Rev A - render extent and openings altered
- 03.09.2025

197
ETZ ST FITTICKS CHURCH
197-P-5-G-(2-)-004A
Phase 2
Proposed External Elevations
SITE

Proposed South Elevation
1:50

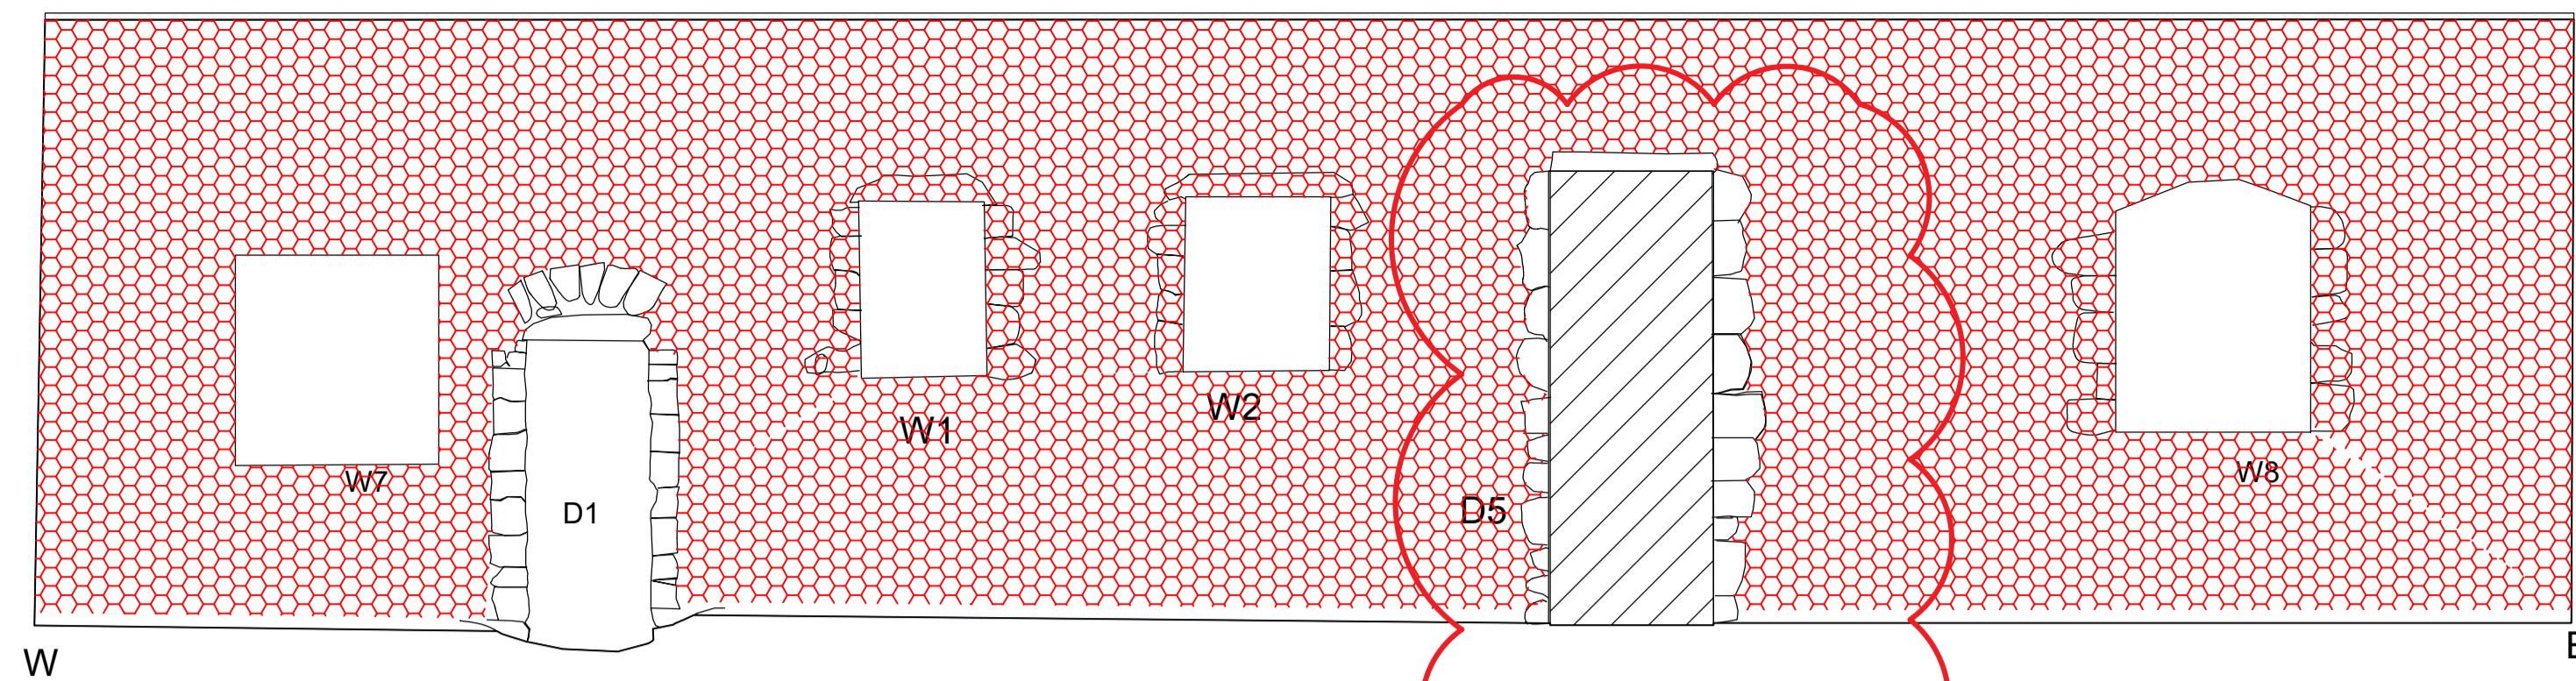
Open up windows as shown on plan.

Proposed North Elevation
1:50

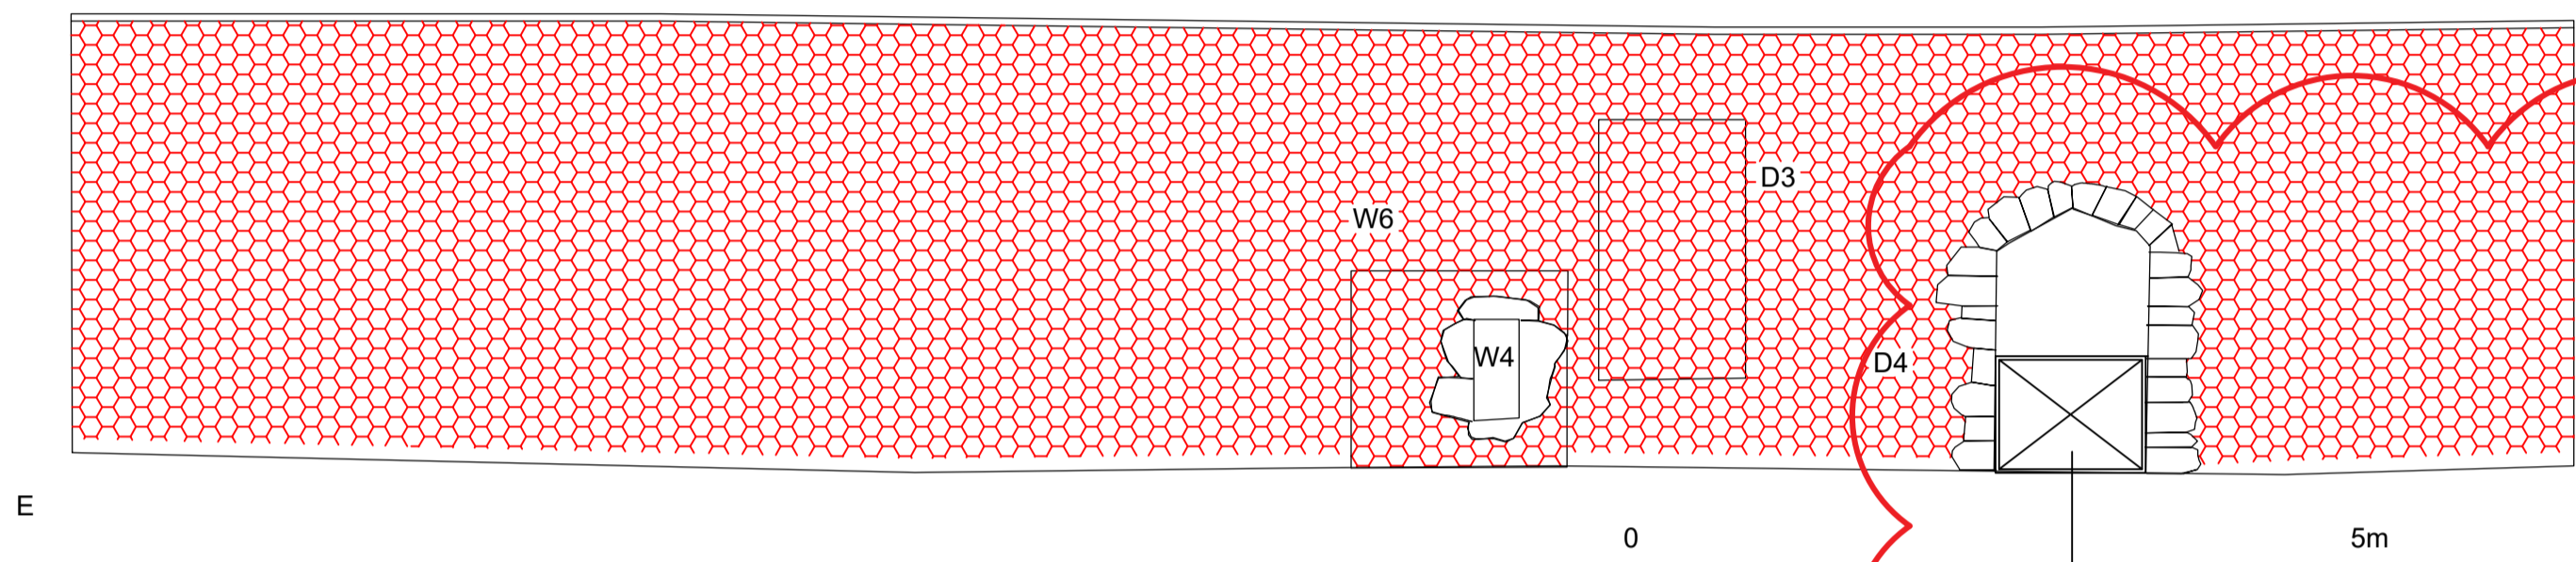
-  Flush pointed stone with no finish
-  Blocked with cement render (on block)
-  Removal of 3-coat cementitious render make good masonry, and re-harl as specified.

Open up doorway by removing stone infill. Bespoke steel screen below 800mm high rail to act as guarding.
